Technical Memorandum

Title	Joe White Malting Plant Response to RMS and Campbelltown Council Comments		
Client	Cargill	Project No	600330
Date	01/05/2017	Status	Version B
Author	Aaron Pau / David Hazell	Discipline	Traffic and Transport
Reviewer	Ivo Pais	Office	Sydney

This technical memorandum is prepared for Cargill in response to comments from Campbelltown Council (email dated 15/02/2017) and Roads and Maritime Services (email dated 20/02/2017) in regards to the Application MP 08_0157.

Figure 3 Inbound Operational Truck Route from the South

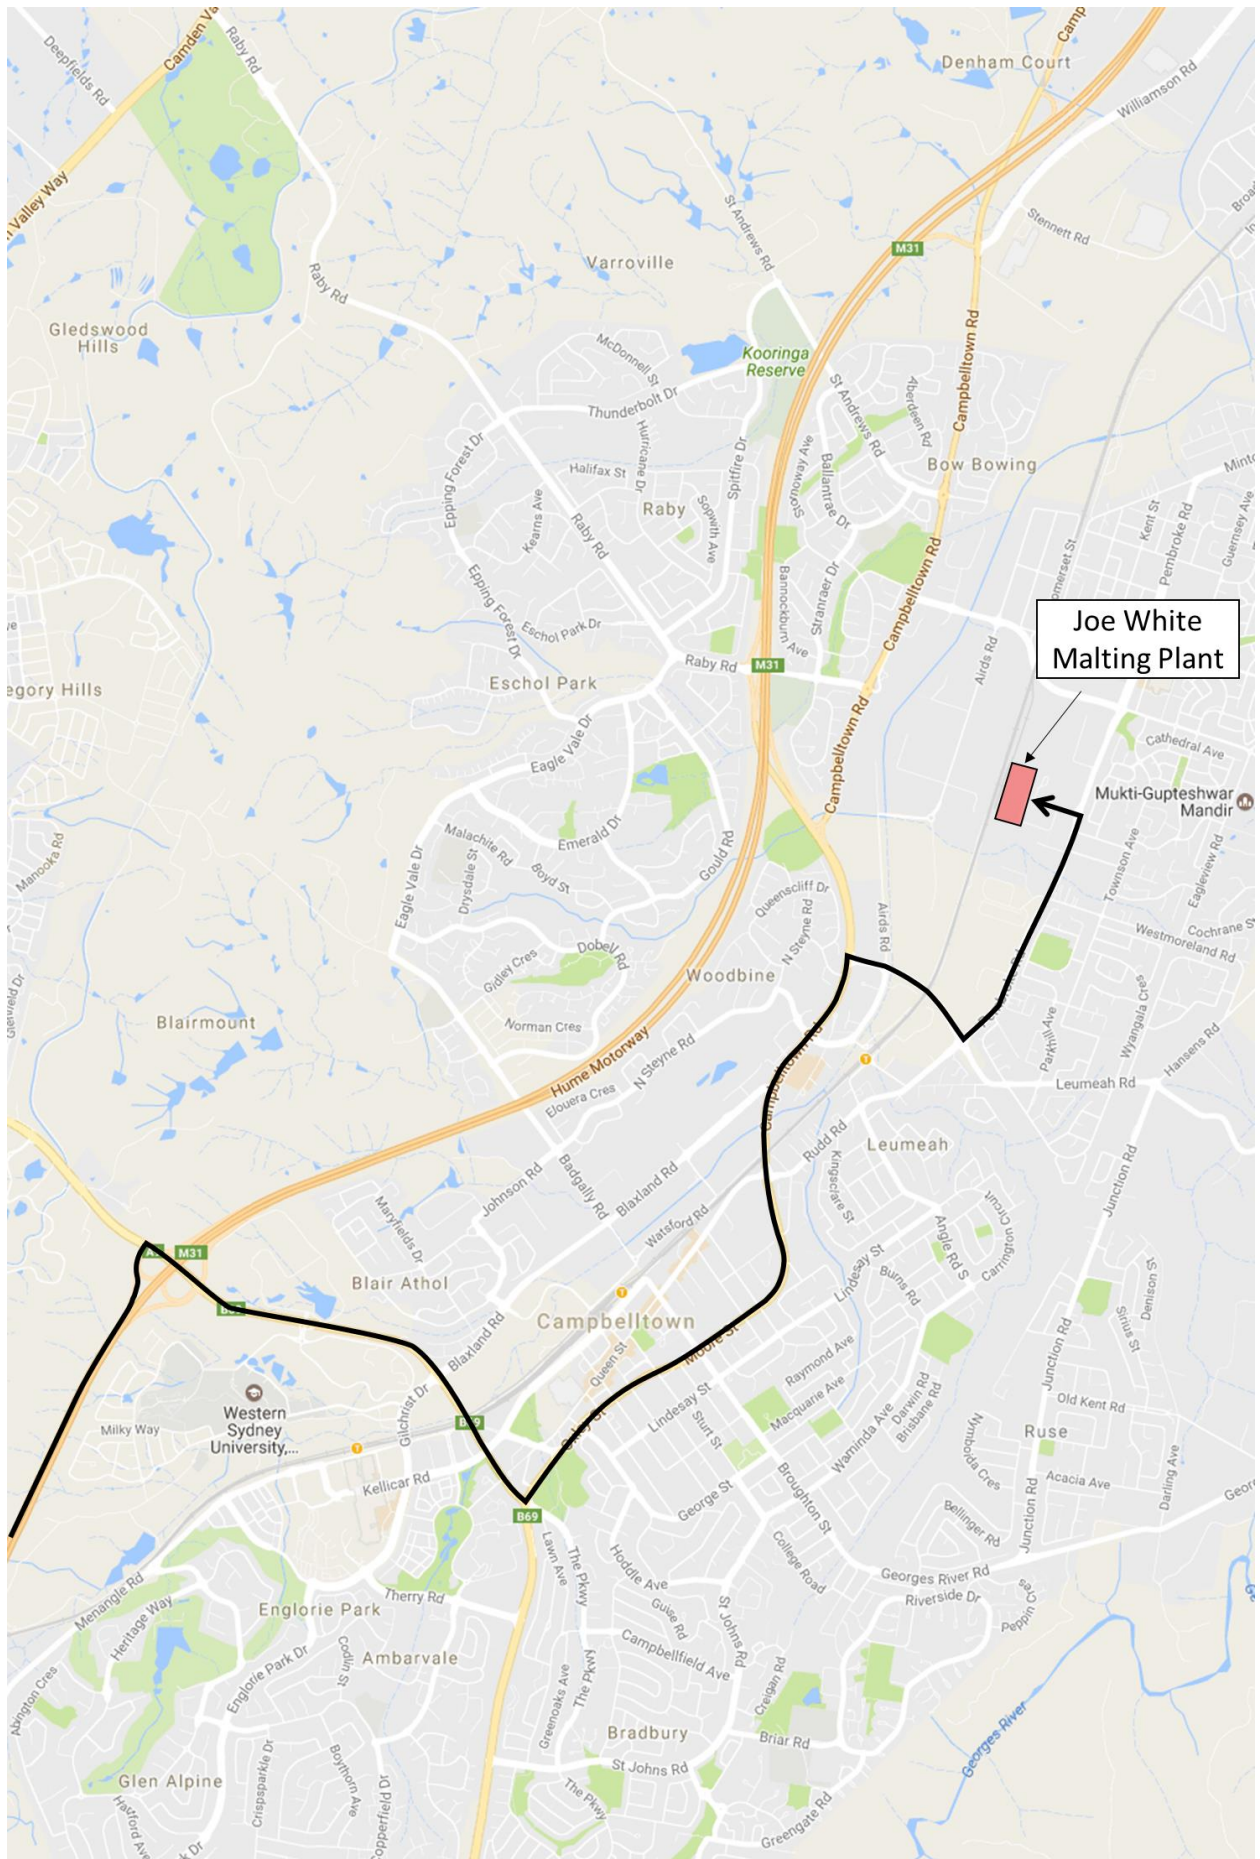
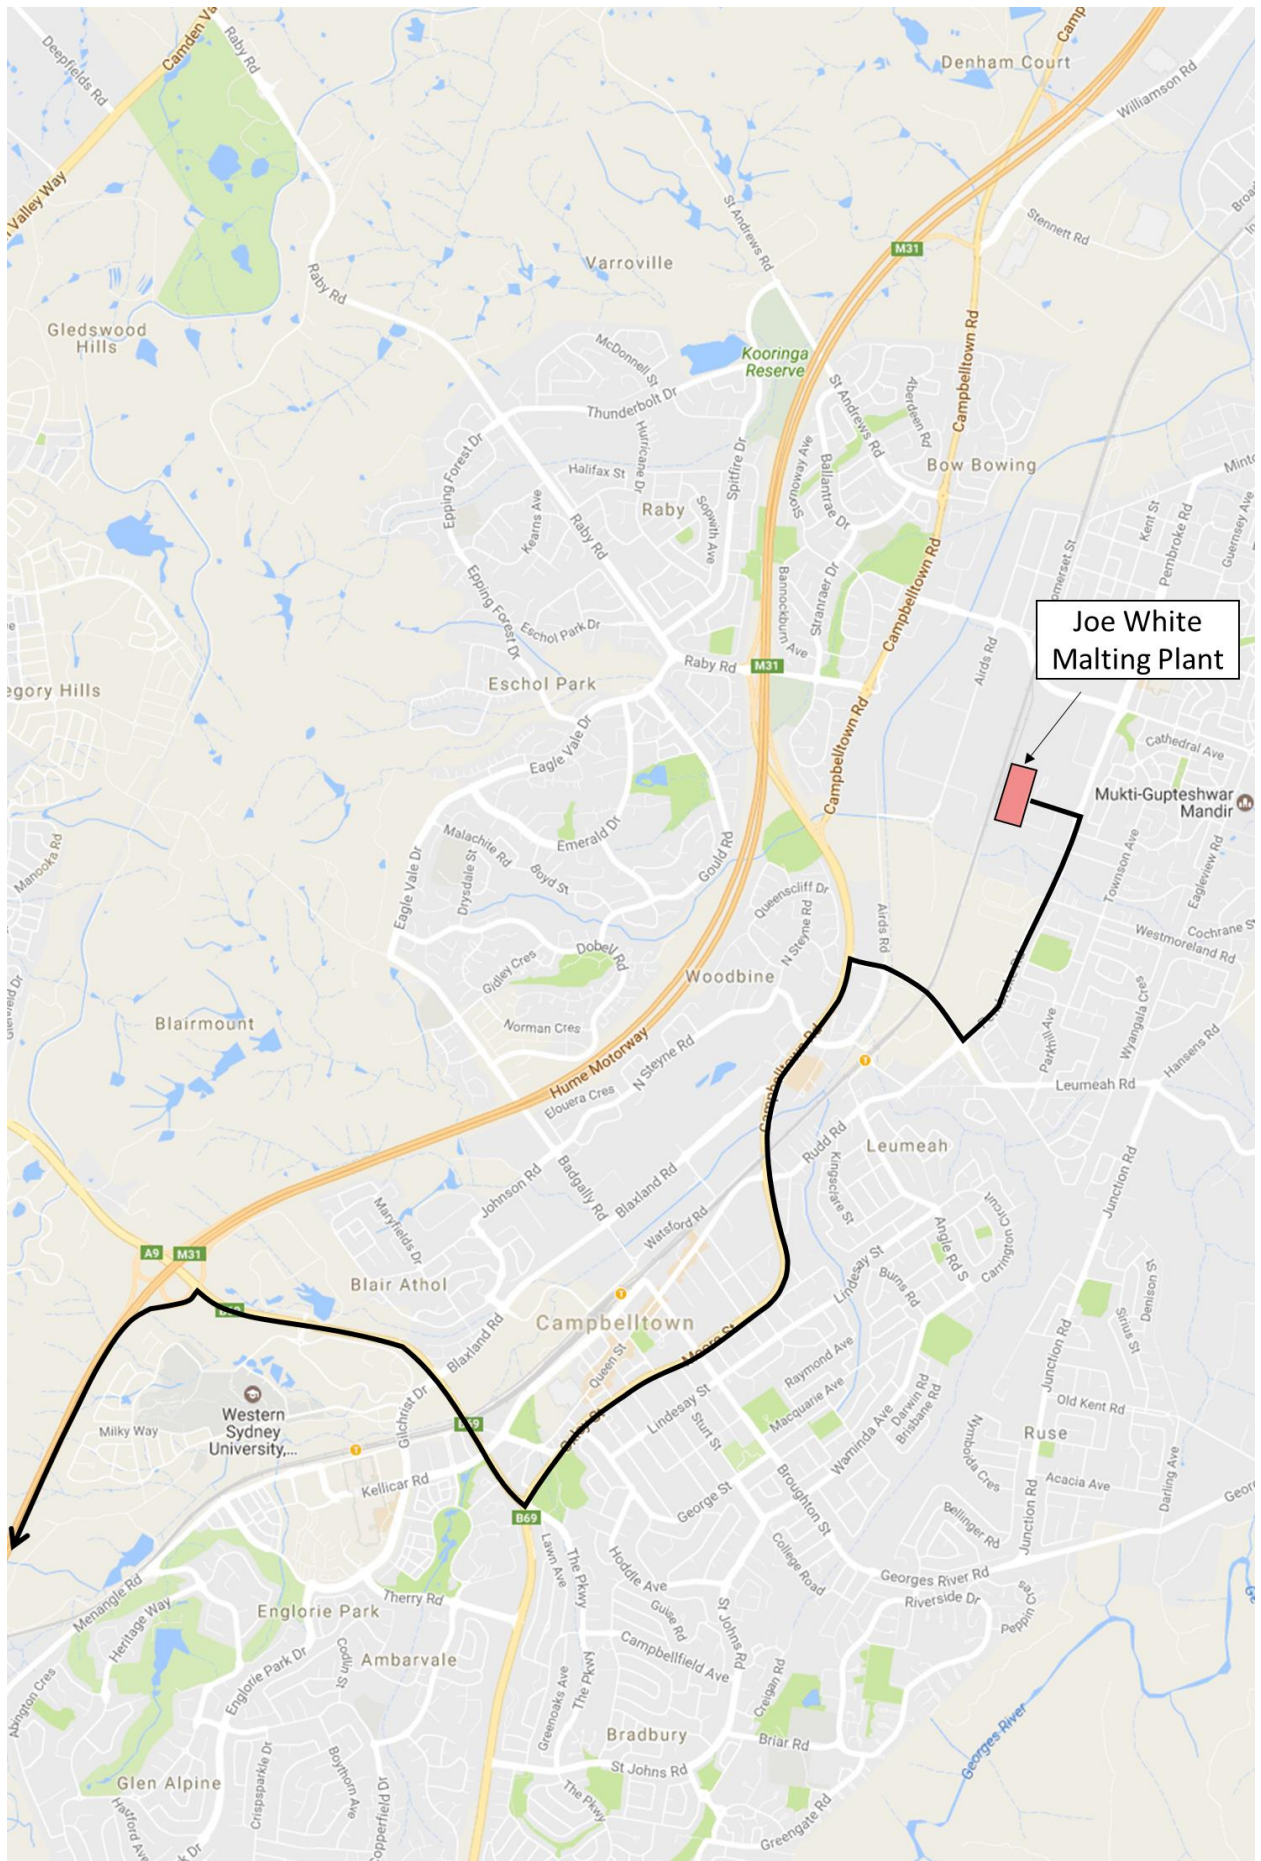
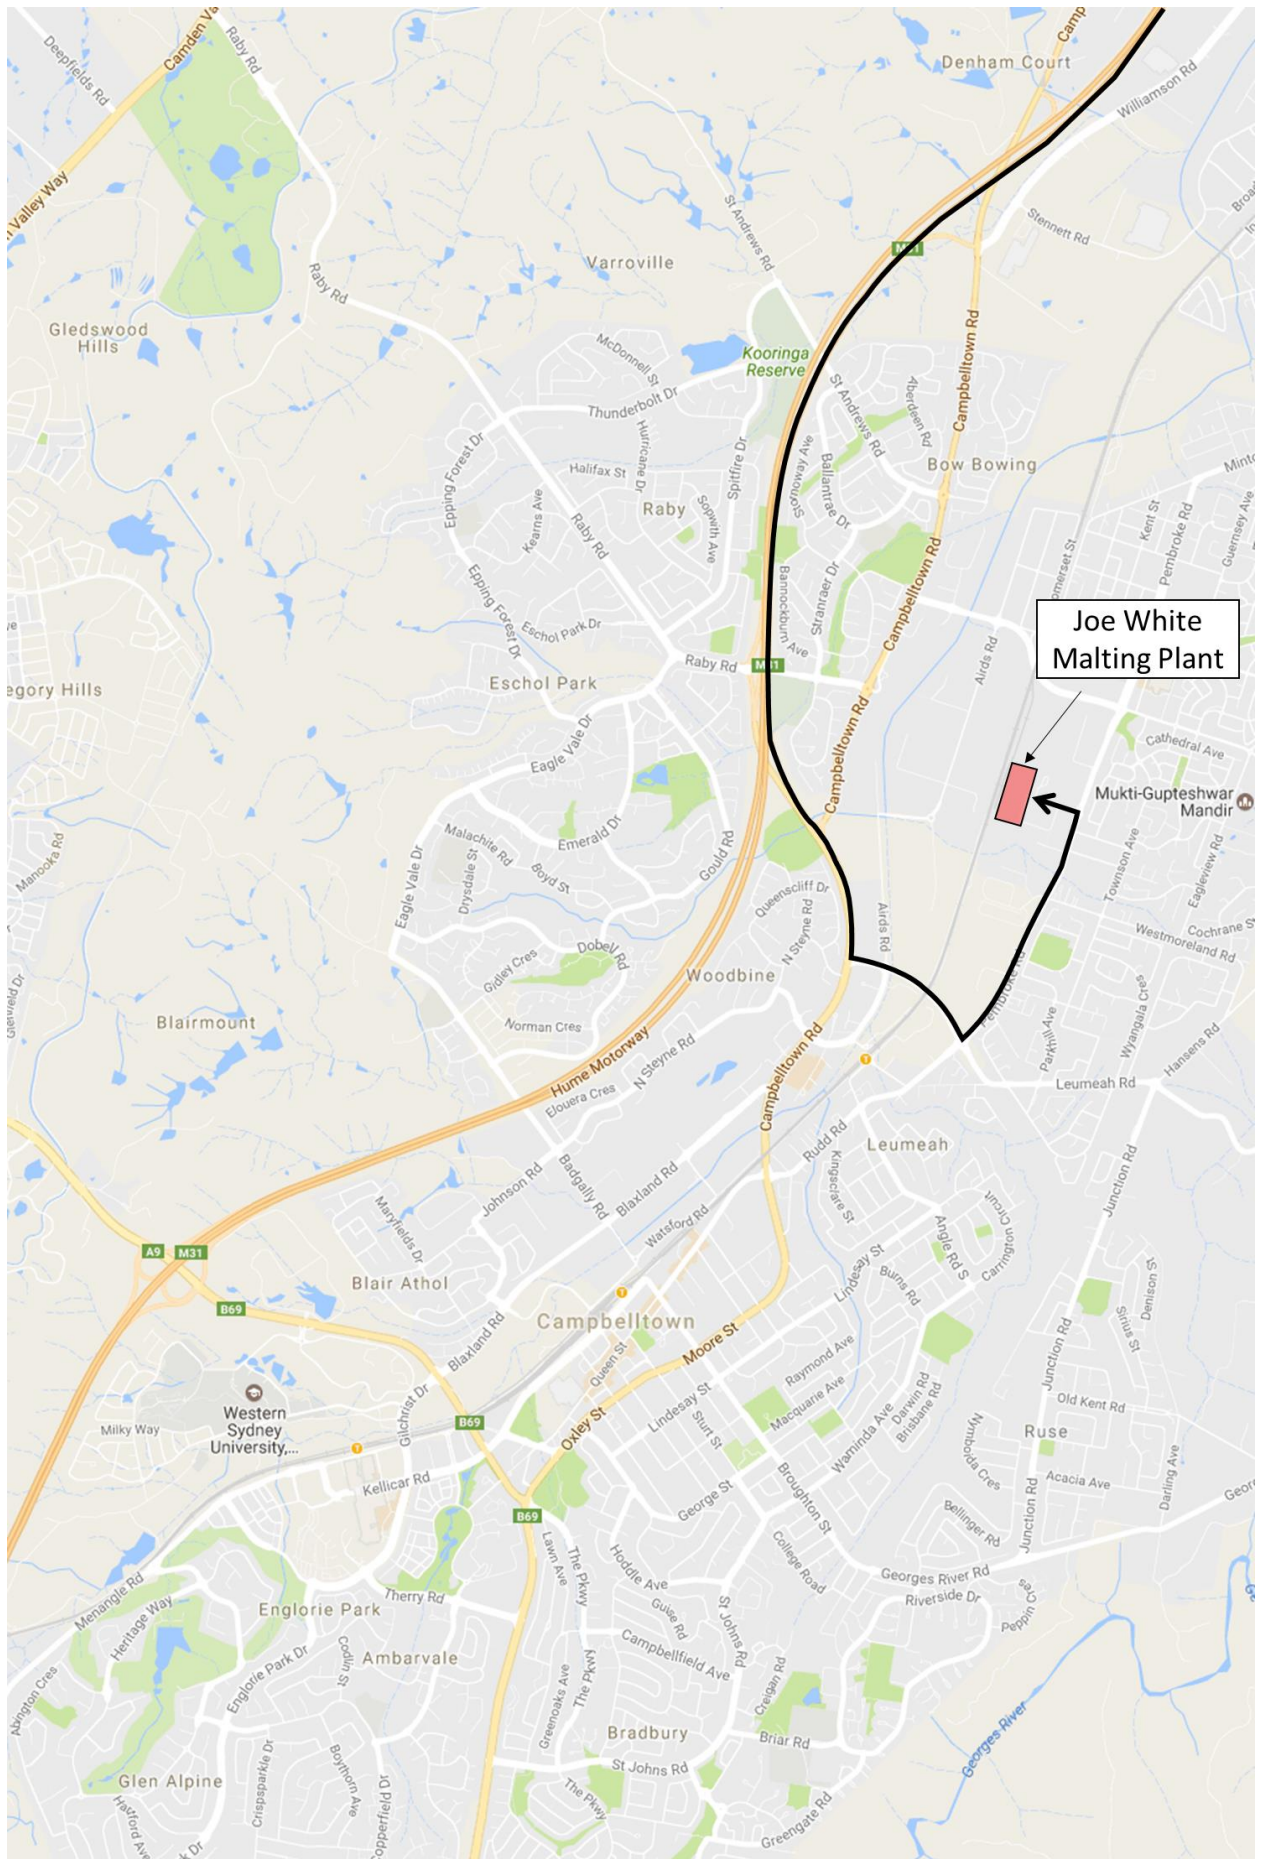
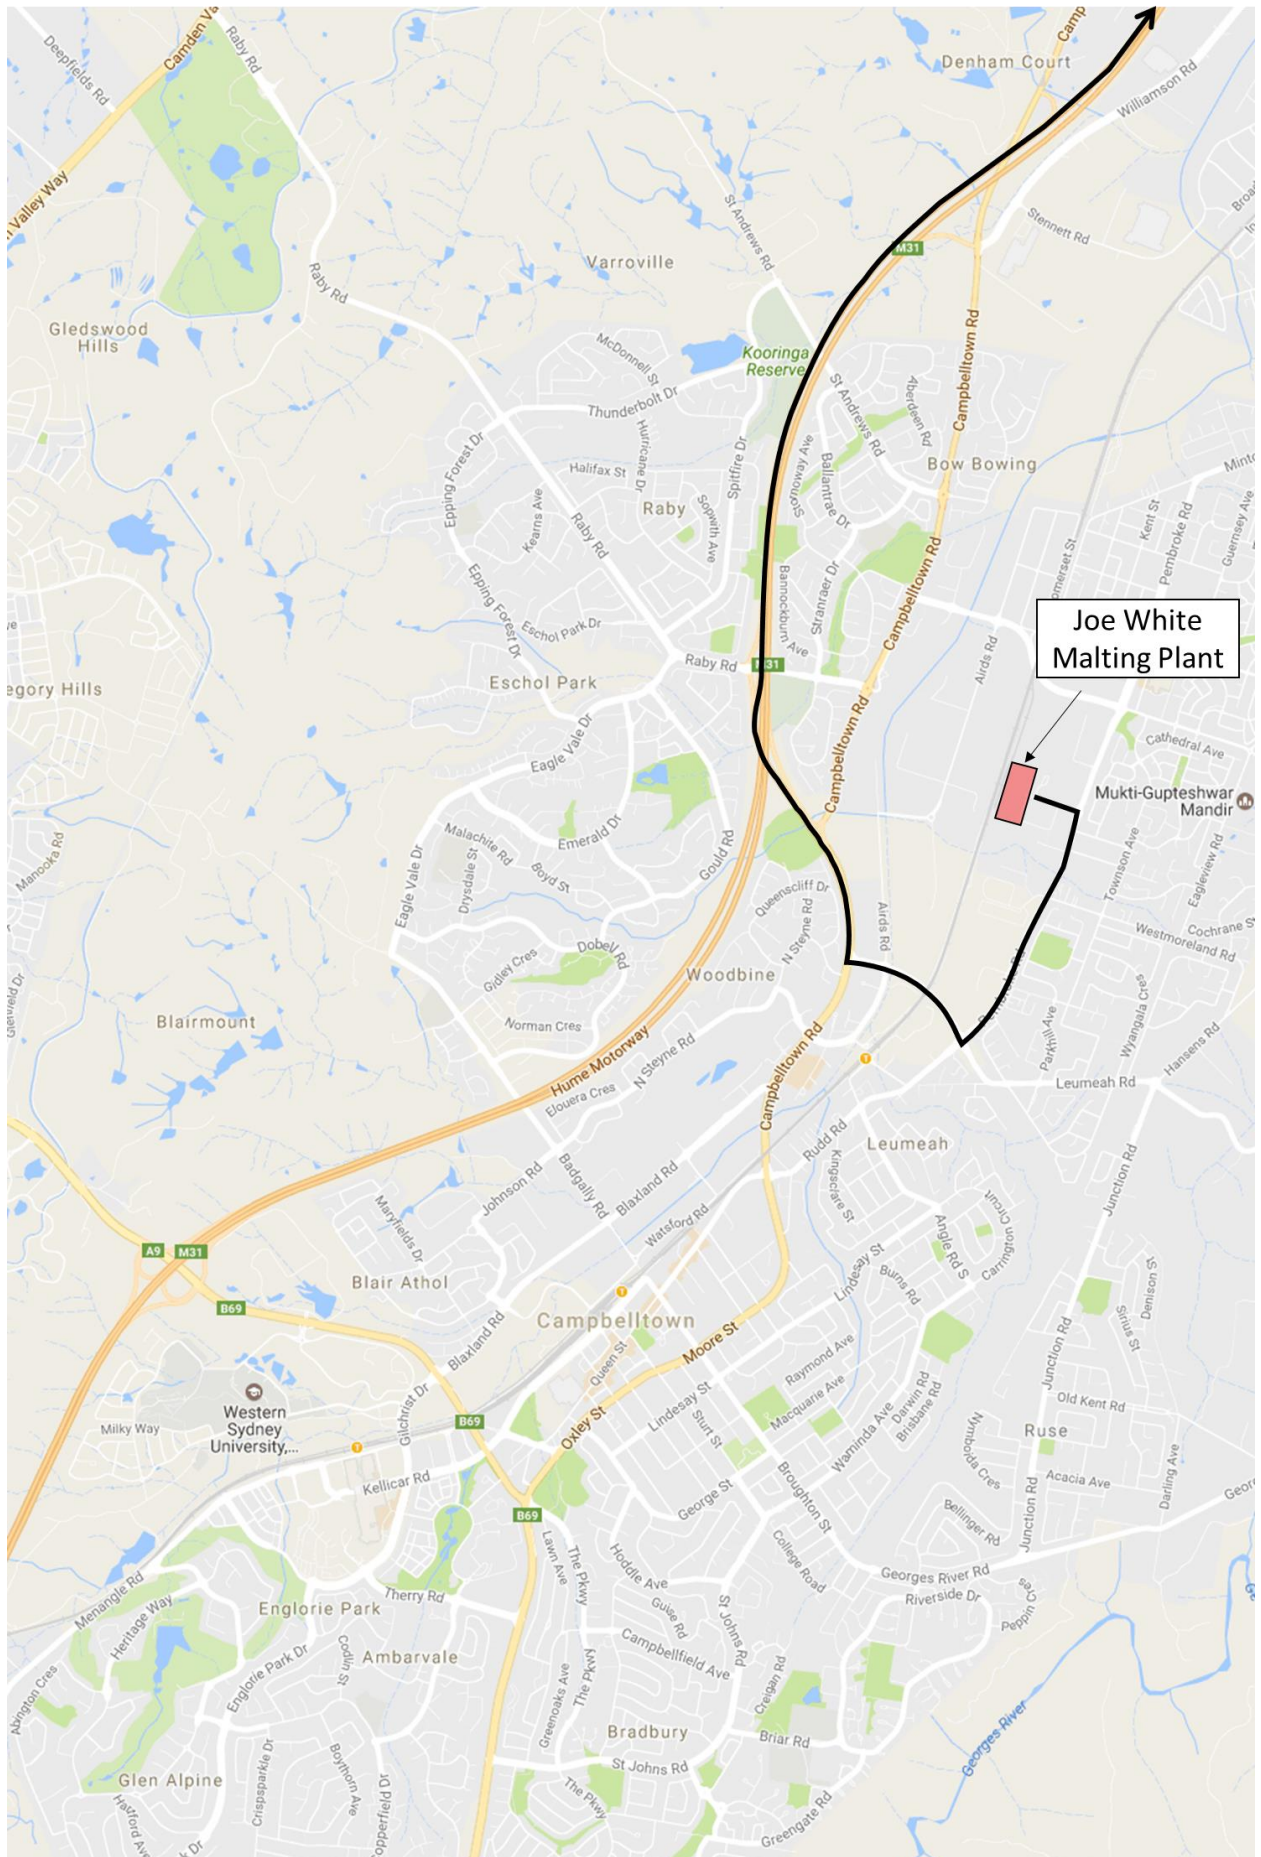
- 2.3.2 The truck routes on page 6 and in Appendix C of the proponent's 'Operational Traffic Management Plan' do not appear to consider the 40 tonne load limit that is applied to the bridge on Ben Lomond Road (between Airds Road and Carey Grove). Further, the right turn proposed from Campbelltown Road to the Hume Highway north is not possible. There are no right turn facilities in that location. A revised route for those movements impacted by the load limit and turn treatments shall be provided.

Cardno has revised the operational routes for the truck movements. The operational routes are based on liaison with Kelvin Baxter Transport who are nominated by Cargill to transport the additional grain.

Figure 3, Figure 4, Figure 5 and Figure 6 illustrates the proposed operational routes.

The operational traffic management plan has been updated (see **Attachment C**).
